RSA Designer Response

ROAD SAFETY AUDIT STAGE 1/2

Project Title	Llay S278
Client	Bellway/Anwyl
Curtins Job Ref No:	065665
RSA Response Ref:	065665-CUR-00-XX-RP-D-9501-V01 Llay S278 RSA 1/2 Designer Response
RSA Report Ref:	610-2020-112-01 Llay Revised S278 Stage 1-2 RSA FINAL (included as Appendix A)

STRAIGHT MILE, GRESFORD ROAD AND CROWN CROSSROADS, LLAY PROPOSED SECTION 278 HIGHWAY WORKS (REVISED DESIGN)

12.1 STRAIGHT MILE

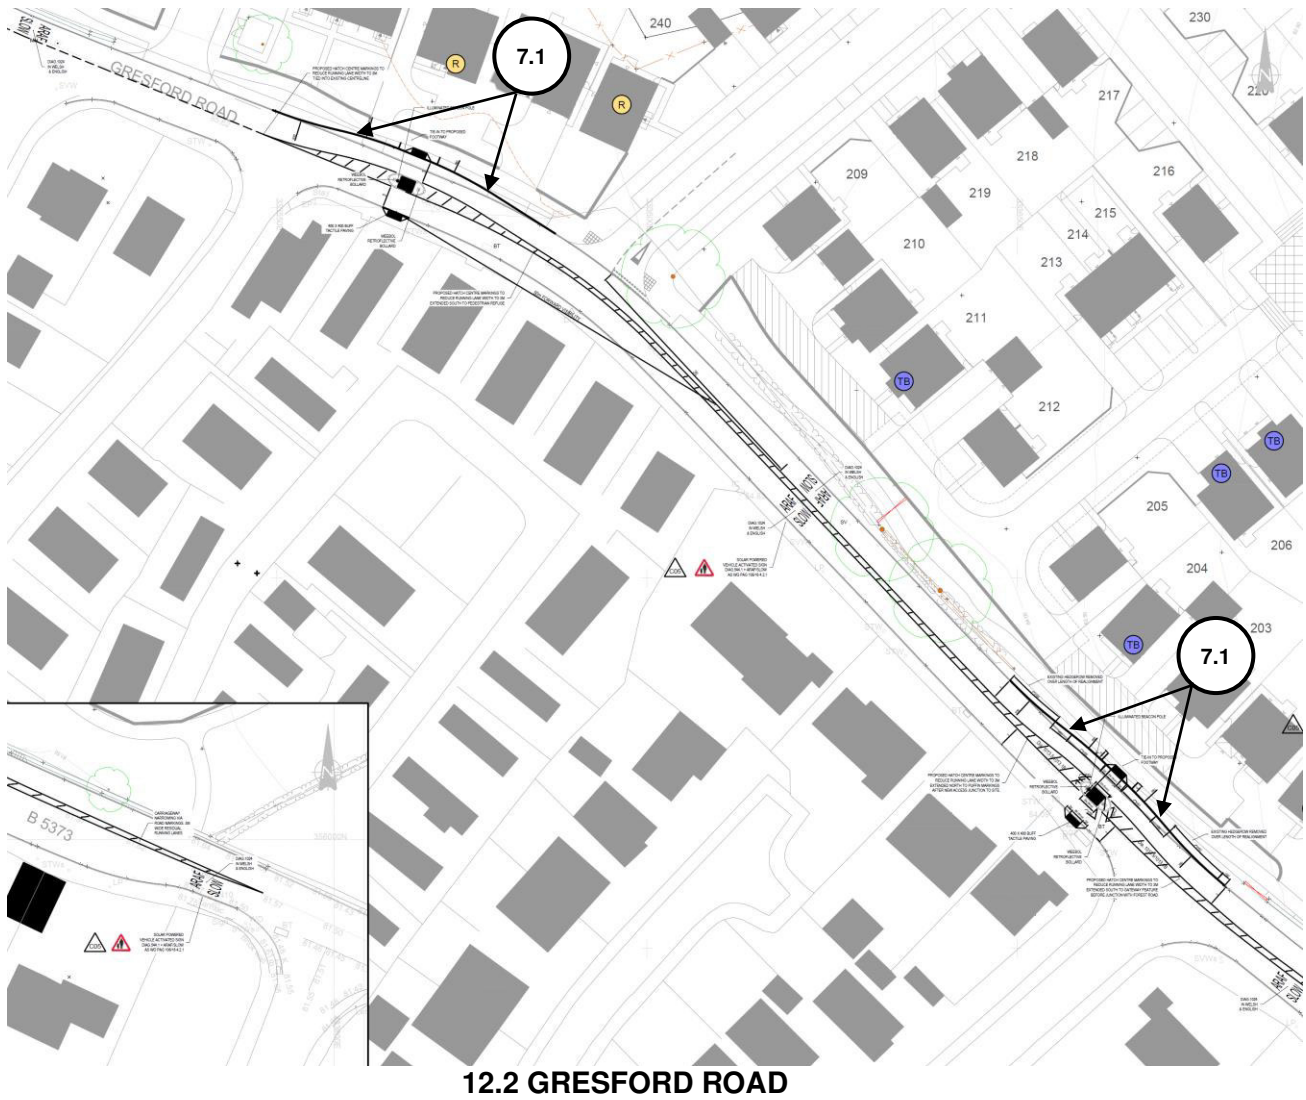
MATTERS ARISING FROM THIS (STAGE 1/2) ROAD SAFETY AUDIT**6.0 STRAIGHT MILE PROPOSED ACCESS****6.1 Location: Straight Mile at proposed junction****Problem****Summary: Possible reduced junction intervisibility due to existing vertical road alignment on Straight Mile**

It was observed during the site visit that the proposed junction is located to the west of an existing blind summit on Straight Mile. This may result in the visibility splay to the east of the junction being reduced due to the blind summit. A reduction in intervisibility at the proposed junction may increase the risk of collisions between those turning out of the access road and those travelling along Straight Mile. Additionally, this may also increase the risk of rear end shunt collisions on Straight Mile due to westbound drivers unaware of vehicles braking for the junction just over the blind summit.

The appropriate junction intervisibility splays in both the horizontal and vertical planes should be checked to ensure suitable intervisibility is provided between the proposed access and those travelling along Straight Mile. Amendments to the junction location should be carried out if appropriate intervisibility cannot be provided at its current location.

6.2 Location: East of proposed junction**Problem****Summary: Possible reduced pedestrian/driver intervisibility due to existing vertical road alignment on Straight Mile**

It was observed during the site visit that the proposed uncontrolled pedestrian crossing to the east of the junction is located to the west of an existing blind summit on Straight Mile. This may result in the intervisibility between pedestrians crossing from the south and drivers travelling westbound being reduced due to the blind summit. A reduction in intervisibility between pedestrians and drivers may increase the risk of pedestrian/vehicular collisions.

In association with item 6.2 above the appropriate pedestrian/driver intervisibility splays in both the horizontal and vertical planes should be checked to ensure suitable intervisibility is provided between these users. Amendments to the uncontrolled crossing location should be carried out if appropriate intervisibility cannot be provided at its current location.

6.3 Location: Eastbound approach to proposed junction**Problem****Summary: Non-standard arrow road marking layout may result in driver confusion**

Two ahead/turn-right road marking arrows are proposed on the eastbound approach to the junction. The provision of these arrows on a single lane approach to this type of junction is non-standard. This may lead to drivers being confused assuming they need to enter the hatched area in order to turn right and they may collide with the pedestrian refuge island. It is also noted there is a lack of deflection arrows on both approaches to the hatched road markings, which could increase the risk of drivers colliding with the central islands.

The two ahead/turn-right road marking arrows on the eastbound approach to the junction should be removed from the design. Deflection arrows at appropriate locations should be provided on the Straight Mile approaches to the hatched road markings.

6.4 Location: Junction of proposed access road and Straight Mile**Problem****Summary: Lack of terminal speed limit signs**

The drawings provided for audit do not show any terminal speed limit signs at the junction of the proposed access road and Straight Mile. It is noted from the drawings for the Crown Crossroads that the speed limit on Straight Mile is being reduced to 40mph, and it is assumed that the access road will have a lower speed limit. If appropriate terminal speed limit signs are not provided, then vehicles may enter the access road at excessive speeds and may increase the severity of any collisions that may occur.

Appropriate terminal speed limit signs should be provided on the access road at the junction with Straight Mile.

Problem Identified (Paragraph No)	Problem Accepted (YES/NO)	Recommendation Accepted (YES/NO/PART)	Response/Action (describe)
STRAIGHT MILE			
6.1 Location: Straight Mile at proposed junction Problem Summary: Possible reduced junction intervisibility due to existing vertical road alignment on Straight Mile It was observed during the site visit that the proposed junction is located to the west of an existing blind summit on Straight Mile. This may result in the visibility splay to the east of the junction being reduced due to the blind summit. A reduction in intervisibility at the proposed junction may increase the risk of collisions between those turning out of the access road and those travelling along Straight Mile. Additionally, this may also increase the risk of rear end shunt collisions on Straight Mile due to westbound drivers unaware of vehicles braking for the junction just over the blind summit. Recommendation The appropriate junction intervisibility splays in both the horizontal and vertical planes should be checked to ensure suitable intervisibility is provided between the proposed access and those travelling along Straight Mile. Amendments to the junction location should be carried out if appropriate intervisibility cannot be provided at its current location.	N	P	The location of the junction on Straight Mile is situated on a stretch of road that falls continuously from west to east for greater than 120 metres in each direction (as indicated by the road levels on drg. 9501). Intervisibility splays, both horizontally and vertically, comply with the requirements for a 40mph speed limit. No design modifications required.

Problem Identified (Paragraph No)	Problem Accepted (YES/NO)	Recommendation Accepted (YES/NO/PART)	Response/Action (describe)
STRAIGHT MILE			
6.2 Location: East of proposed junction Problem Summary: Possible reduced pedestrian/driver intervisibility due to existing vertical road alignment on Straight Mile It was observed during the site visit that the proposed uncontrolled pedestrian crossing to the east of the junction is located to the west of an existing blind summit on Straight Mile. This may result in the intervisibility between pedestrians crossing from the south and drivers travelling westbound being reduced due to the blind summit. A reduction in intervisibility between pedestrians and drivers may increase the risk of pedestrian/vehicular collisions. Recommendation In association with item 6.2 above the appropriate pedestrian/driver intervisibility splays in both the horizontal and vertical planes should be checked to ensure suitable intervisibility is provided between these users. Amendments to the uncontrolled crossing location should be carried out if appropriate intervisibility cannot be provided at its current location.	N	P	The location of the junction on Straight Mile is situated on a stretch of road that falls continuously from west to east for greater than 120 metres in each direction (as indicated by the road levels on drg. 9501). Intervisibility splays, both horizontally and vertically, comply with the requirements for a 40mph speed limit. No design modifications required.

Problem Identified (Paragraph No)	Problem Accepted (YES/NO)	Recommendation Accepted (YES/NO/PART)	Response/Action (describe)
STRAIGHT MILE			
6.3 Location: Eastbound approach to proposed junction Problem Summary: Non-standard arrow road marking layout may result in driver confusion Two ahead/turn-right road marking arrows are proposed on the eastbound approach to the junction. The provision of these arrows on a single lane approach to this type of junction is non-standard. This may lead to drivers being confused assuming they need to enter the hatched area in order to turn right and they may collide with the pedestrian refuge island. It is also noted there is a lack of deflection arrows on both approaches to the hatched road markings, which could increase the risk of drivers colliding with the central islands. Recommendation The two ahead/turn-right road marking arrows on the eastbound approach to the junction should be removed from the design. Deflection arrows at appropriate locations should be provided on the Straight Mile approaches to the hatched road markings.	Y	P	Non-standard arrow road marking deleted.

6.4 Location: Junction of proposed access road and Straight Mile Problem Summary: Lack of terminal speed limit signs The drawings provided for audit do not show any terminal speed limit signs at the junction of the proposed access road and Straight Mile. It is noted from the drawings for the Crown Crossroads that the speed limit on Straight Mile is being reduced to 40mph, and it is assumed that the access road will have a lower speed limit. If appropriate terminal speed limit signs are not provided, then vehicles may enter the access road at excessive speeds and may increase the severity of any collisions that may occur. Recommendation Appropriate terminal speed limit signs should be provided on the access road at the junction with Straight Mile.	Y	P	These are included on the S38 design for the estate road.

12.3 CROWN CROSSROADS

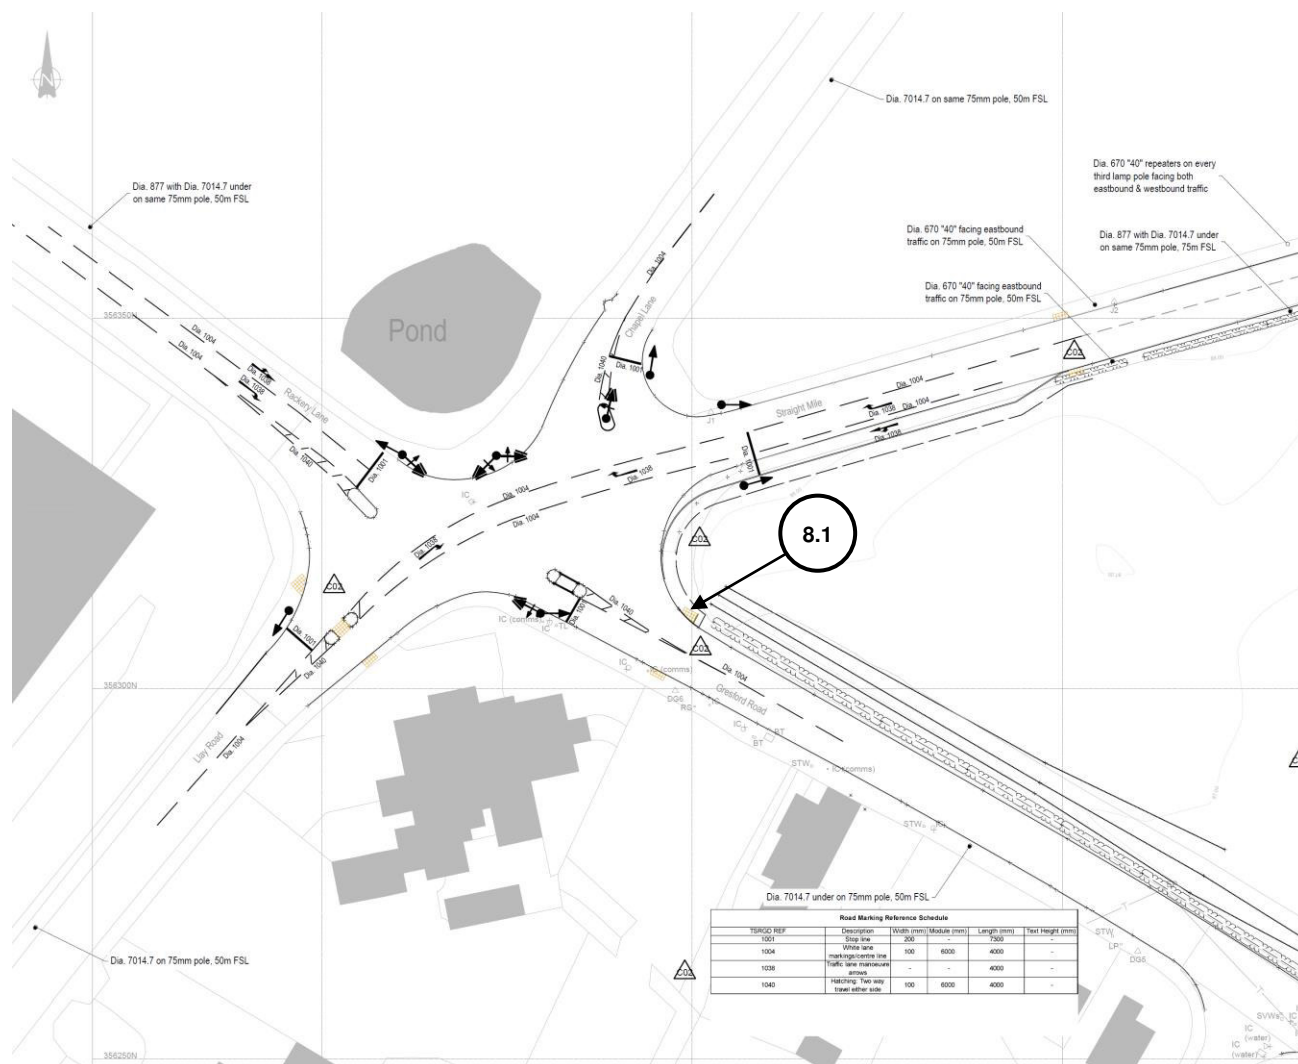
8.1 Location: Gresford Road northern uncontrolled pedestrian crossing point

Summary: Possible reduced pedestrian/driver intervisibility

The location of the uncontrolled pedestrian crossing point on the northern side of Gresford Road may result in the intervisibility between pedestrians crossing from the north and drivers turning left from Straight Mile being reduced due to the boundary treatment on the east side of the junction. A reduction in intervisibility between pedestrians and drivers may increase the risk of pedestrian/vehicular collisions.

The appropriate pedestrian/driver intervisibility splays should be checked to ensure suitable intervisibility is provided between these users. The proposed boundary treatment should not obscure the intervisibility splay and the uncontrolled crossing should be relocated if required.

Problem Identified (Paragraph No)	Problem Accepted (YES/NO)	Recommendation Accepted (YES/NO/PART)	Action (describe)
CROWN CROSSROADS			
8.1 Location: Gresford Road northern uncontrolled pedestrian crossing point Problem Summary: Possible reduced pedestrian/driver intervisibility The location of the uncontrolled pedestrian crossing point on the northern side of Gresford Road may result in the intervisibility between pedestrians crossing from the north and drivers turning left from Straight Mile being reduced due to the boundary treatment on the east side of the junction. A reduction in intervisibility between pedestrians and drivers may increase the risk of pedestrian/vehicular collisions. Recommendation The appropriate pedestrian/driver intervisibility splays should be checked to ensure suitable intervisibility is provided between these users. The proposed boundary treatment should not obscure the intervisibility splay and the uncontrolled crossing should be relocated if required.	Y	Y	Boundary fence is Cheshire Rail so has good through visibility. Verge between back of footway and fence to be topsoil and grass seeded. WCBC to maintain verge so grass height does not exceed 600mm.
